1CAN020008

Subject: Arkansas Nuclear One - Unit 1
Docket No. 50-313
License No. DPR-51
Supplemental Information Regarding Hot Leg Nozzle RC-1071/1072

**Appendix C to
Framatome Report 32-5007242-02**

Picture 1 of Repaired Nozzle RC-1071/1072

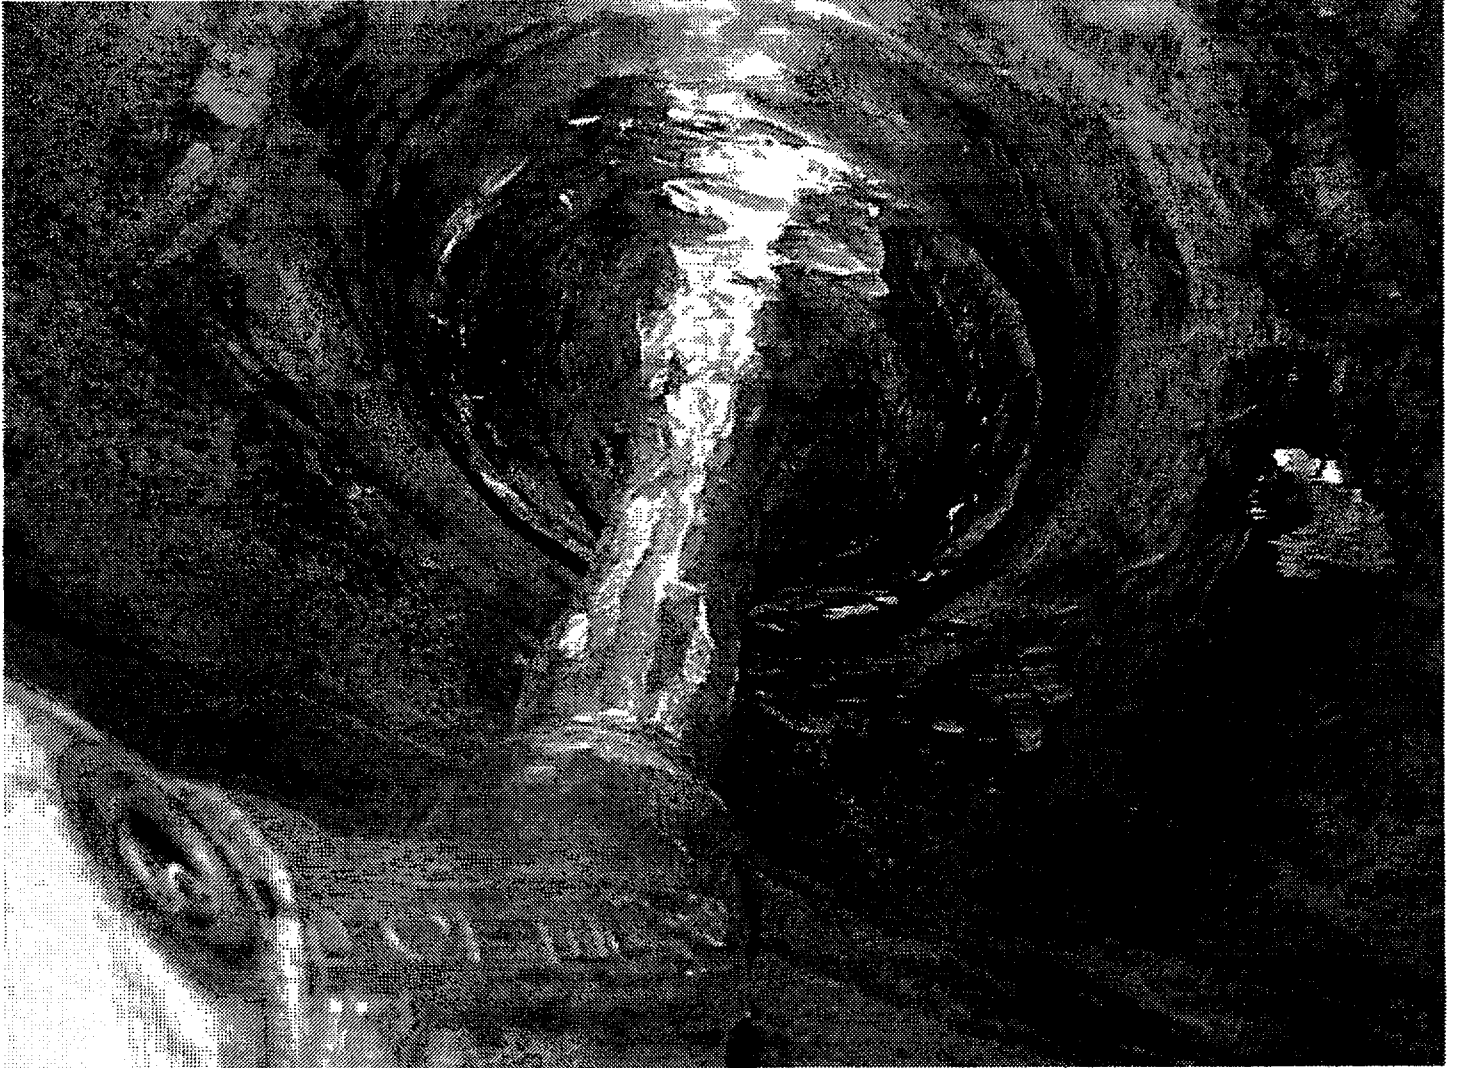
Two pictures of the new nozzle configuration are being provided for information. These pictures show a reducer which transitions the 1 inch valve to the 3/4 inch nozzle as they approach the valves as shown on our Figure 7-1 of our February 25, 2000 submittal. The wall thickness of the nozzle has not been reduced and retains its Code requirements for minimum wall thickness. The weld repair was performed using Framatome welding procedures and welders certified under their program for this welding application. Since a minimum of a 200 degree F preheat temperature was maintained during initial weld pad installation, a temper bead process was not required.

Figure C-1. Embedded Flaw Model for Weld Pad

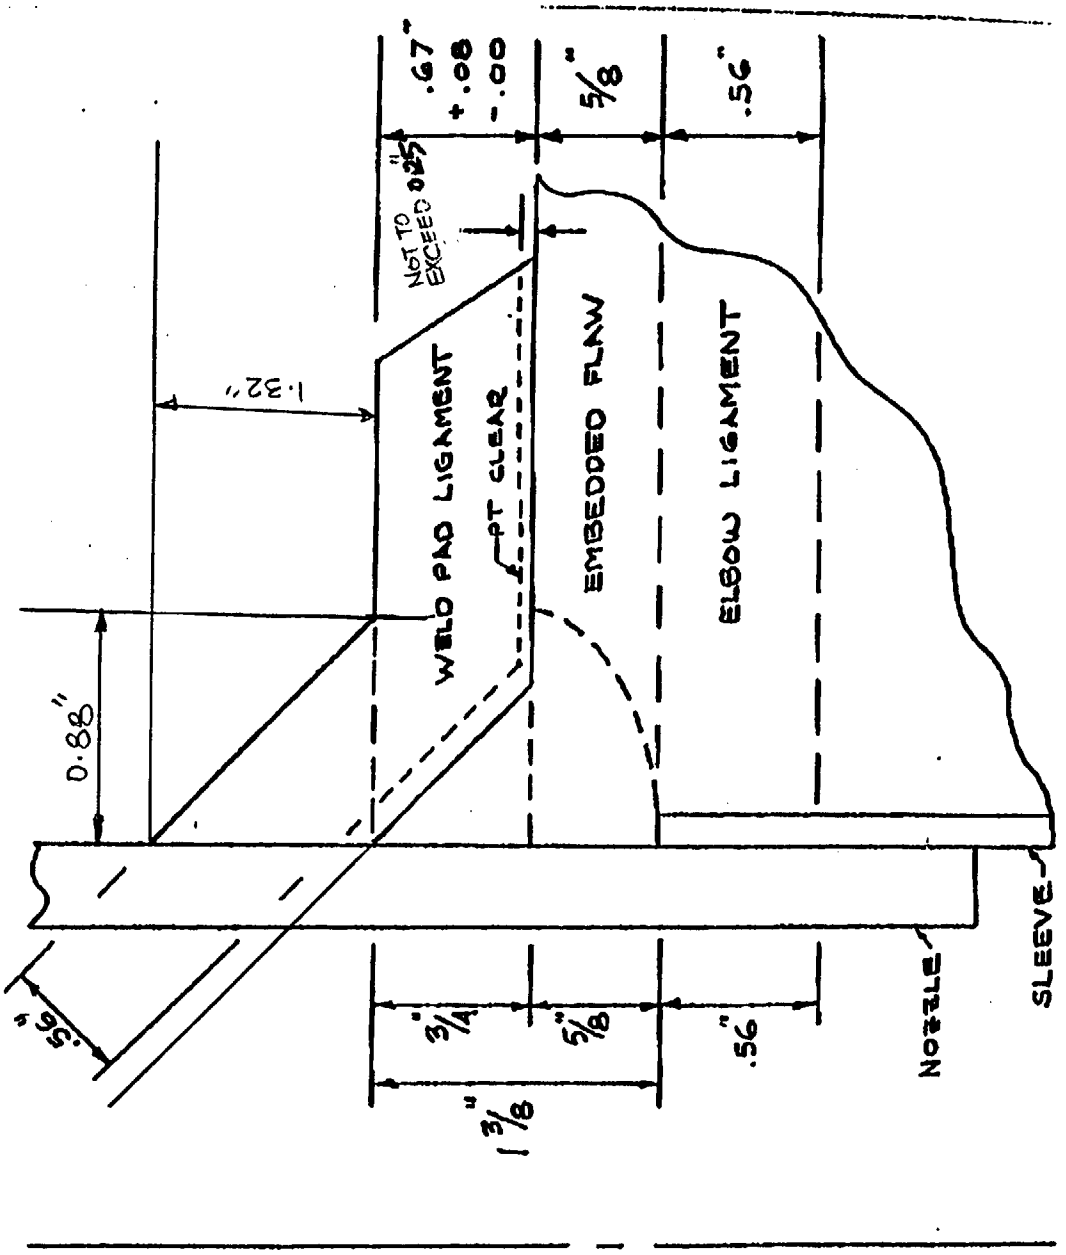
that was performed was the same as that process previously considered for the initial flaw evaluation considered by the NRC staff. The results of the additional flaw analysis resulted in the weld pad and the new fillet weld dimensions increasing. A diagram of the dimensions for the new weld is shown on Figure C-1, which is enclosed in the flaw evaluation details of Appendix C to Framatome Report 32-5007242-02 (Enclosure 2). There have been no indications that cracks exist in the nozzle itself. The inside diameters of two nozzles removed from other locations have been inspected with no indications identified.

The weld pad design proposed in our February 24 and February 25, 2000 submittals increased from 0.62 inch to 0.75 inch and the fillet weld increased from 0.5 inch weld with a 2:1 taper to an approximate 0.88 inch weld with a 1.5:1 taper. The weld pad buildup, and the increased weld height (along the nozzle axis) will serve to stiffen the nozzle. This taper is considered acceptable based on the same EPRI report (EPRI Report TR-107455) that provides a quantitative estimate of the improvement with a 2 to 1 taper and notes that any increases in the length of the axial leg improve vibration resistance. The EPRI study did not quantify the amount of improvement for increases over 1 to 1, other than to note that they exist, and to suggest further quantification of the amount as one of the areas for potential further study. Entergy did not credit either the initial 2:1 taper or the revised 1.5:1 taper in the quantitative vibrational analysis. Prior to weld pad buildup, the assembly exhibited a first bending mode at 25.5 hertz and a torsional mode was also experienced at 21.7 hertz. After welding was completed, the first bending mode had increased to 31.9 hertz and the torsional mode increased to 22.5 hertz. This moves the frequency further away from the motor running speed vibrations present at approximately 20 hertz, and will reduce the vibrational stresses accordingly.

An embedded flaw is postulated to be present between the elbow and the weld pad. This flaw can be considered to be a compound flaw formed by the 5/8" deep J-groove flaw, analyzed for the carbon steel elbow material (Table 1), and the triangular shaped area inside the PT clear profile shown in Figure C-1 [1,12]. The PT clear line, which is outside the original fillet weld, is truncated by the line along the top of the weld pad at 3/4" above the elbow surface. The total depth of the postulated flaw is the sum of the 5/8" deep J-groove and the 3/4" high triangular void, or 1 3/8". The specified thickness of the weld ligament in the region is 0.56", and since the design thickness of the pad is 1/2", there is a 0.060" allowance for crack growth. Although there is about 3" of elbow base metal below the flaw, only 0.56" will be credited to create a symmetric center cracked panel (CCP) model.
